Village of Mukwonago
Notice of Meeting and Agenda

PLAN COMMISSION MEETING
Tuesday, October 13, 2020

- 5.2 Discussion and recommendation to Village Board on **RESOLUTION 2020-55** a Resolution to approve Site Plan and Architectural Review for Malcolm Drilling, Applicant; 120 Hill Ct; Parcel #A486800002

- 5.3 Discussion and recommendation to Village Board on **RESOLUTION 2020-56** a Resolution to approve Site Plan and Architectural Review for Grey Fox Holdings, Applicant; 704 Cardinal Ln Unit 1; Parcel MUKV 2091-989-098; 704 Cardinal Ln Unit 2; Parcel MUKV 2091-989-099; 704 Cardinal Ln Unit 3; Parcel MUKV 2091-989-100; 704 Cardinal Ln Unit 4; Parcel MUKV 2091-989-101.
[Staff report for 704 Cardinal Ln.pdf](#)
[RESOLUTION 2020-56 SPAR 704 Cardinal Ln.pdf](#)

**SITE GRADING
AND UTILITY PLAN**

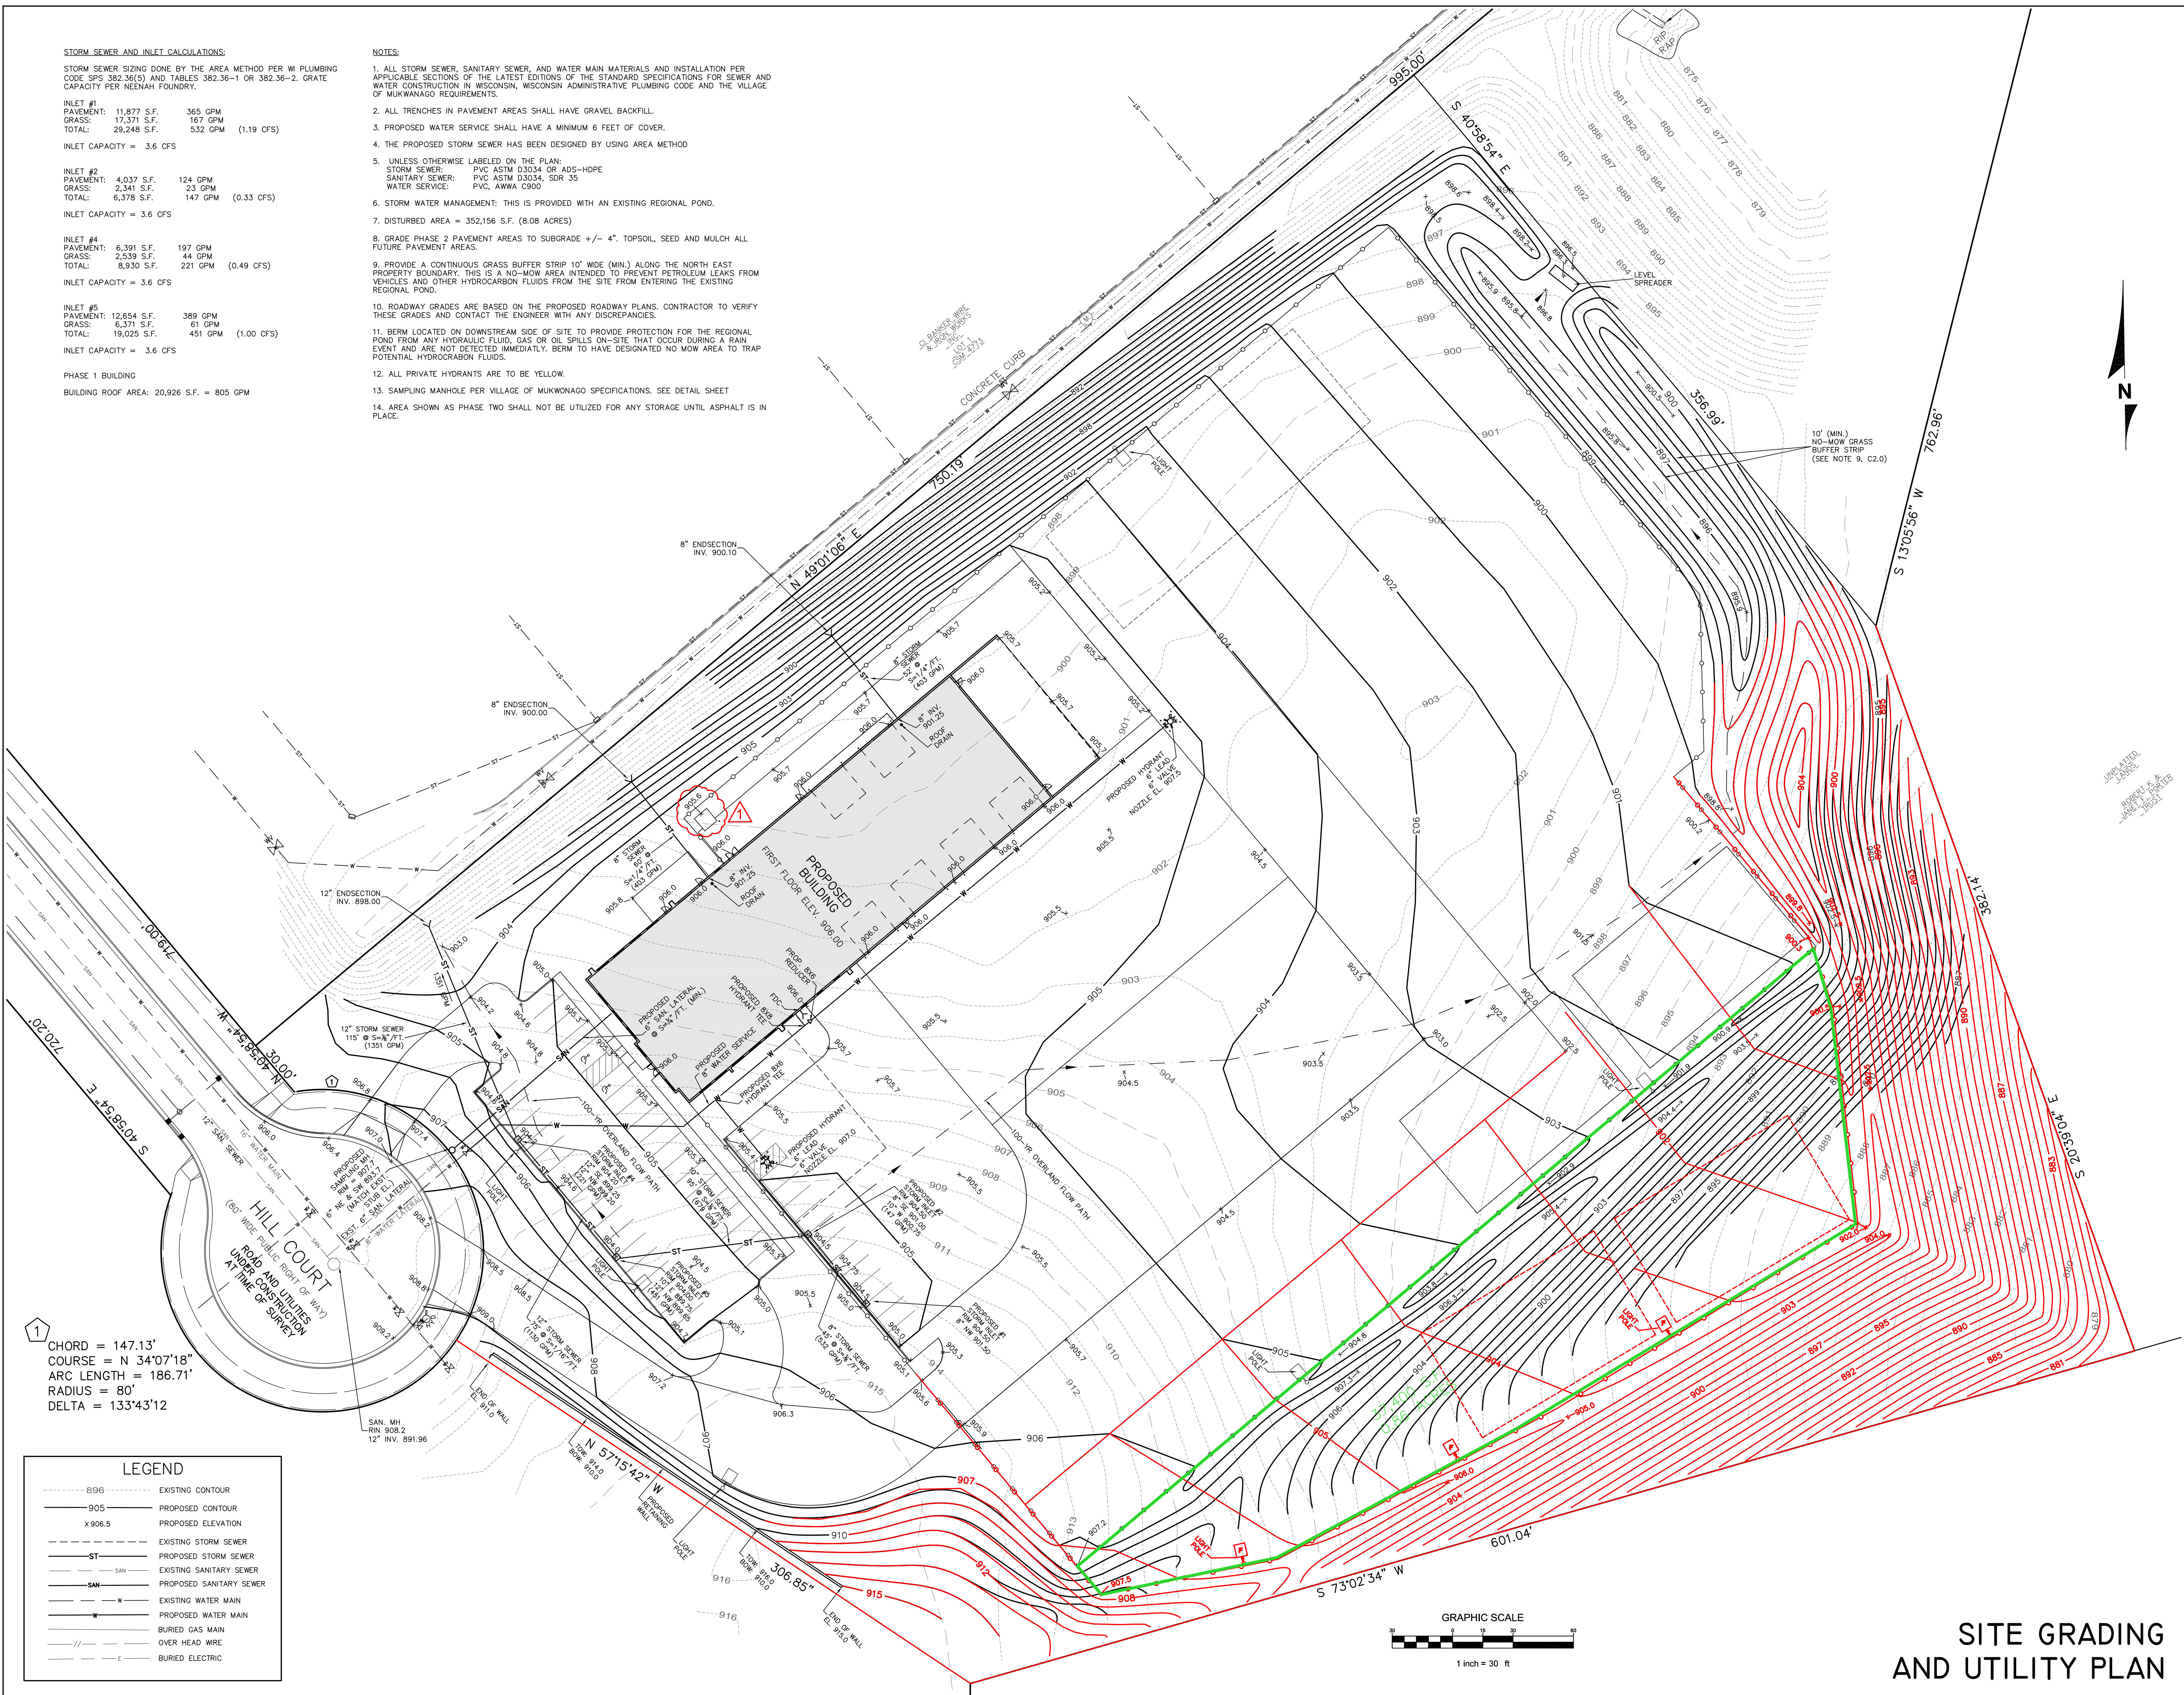
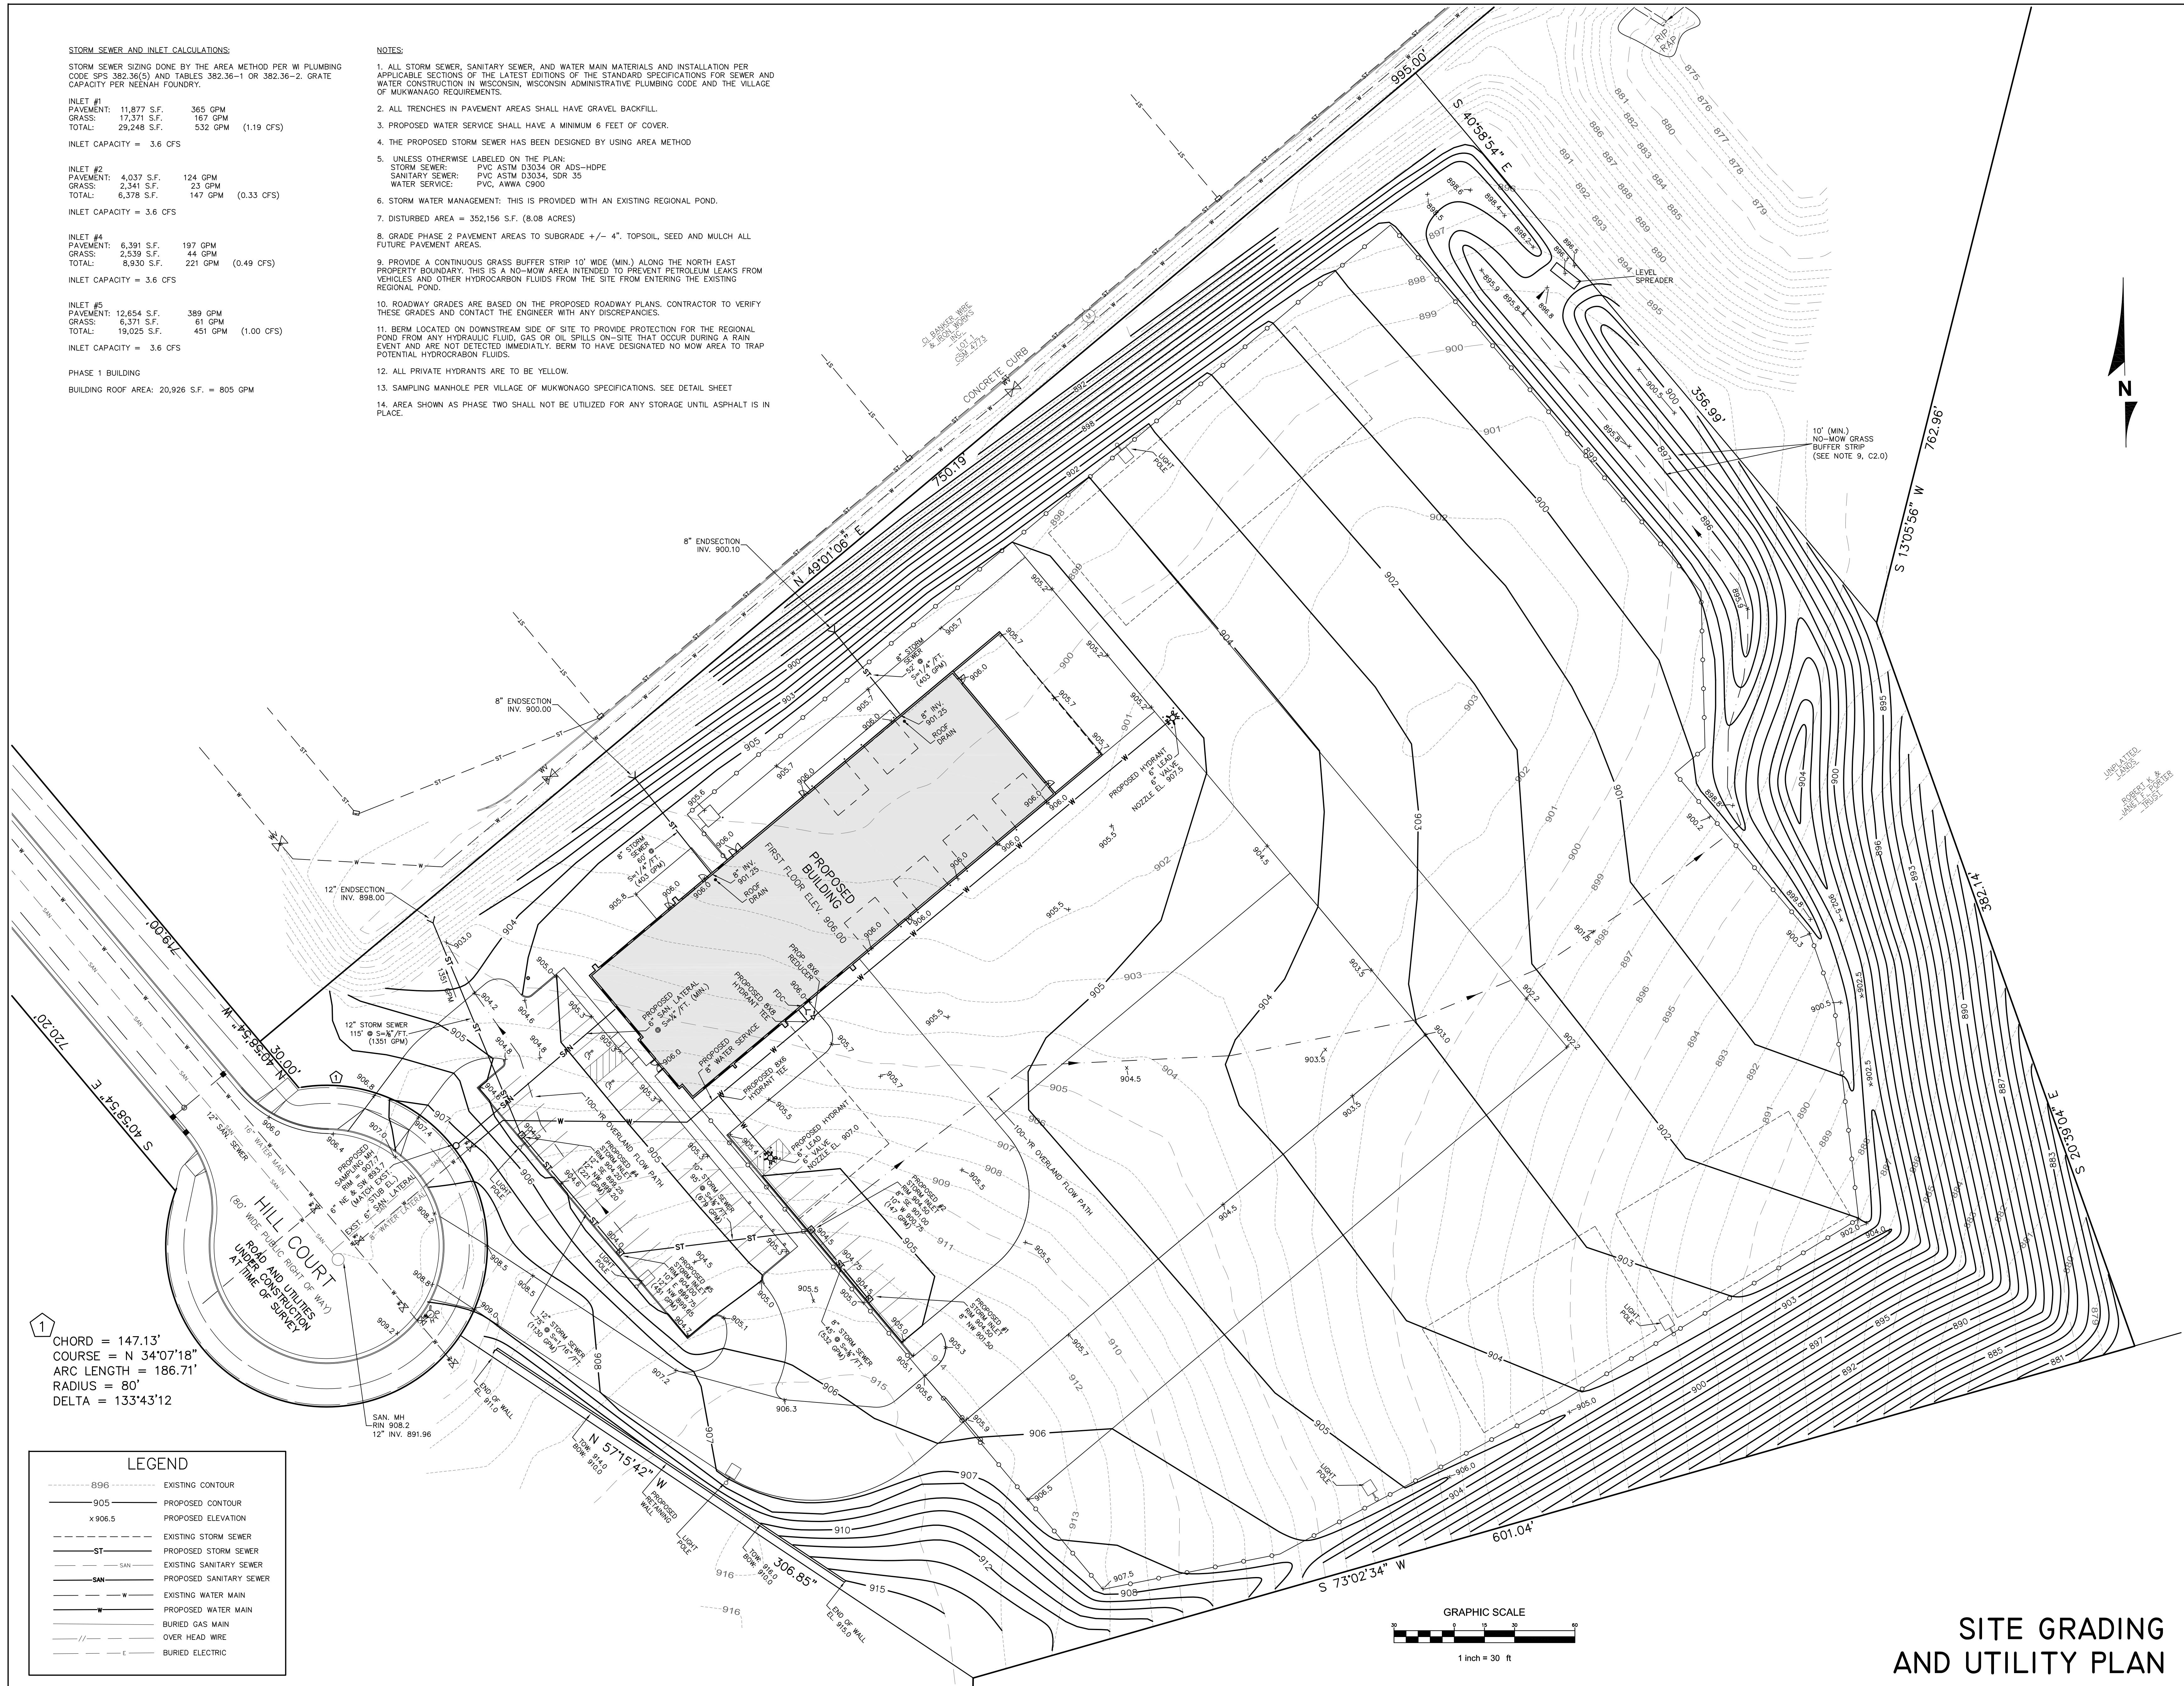
General description Malcolm Drilling is proposing a revision of the site plan as follows:

Outdoor lighting A new photometric plan has been prepared. It complies with the standards at the lot line (zero foot-candles).

Landscaping plan The proposed expansion will not impact any existing or planned plantings.

3. All work related to this project must comply with all project plans approved by the Village.
4. The applicant must address all of the concerns of the Village engineer with regard to stormwater management.

5. The applicant must address all of the concerns of the Village planner that shows compliance with the Village's outdoor lighting standards and obtain the approval of the same.
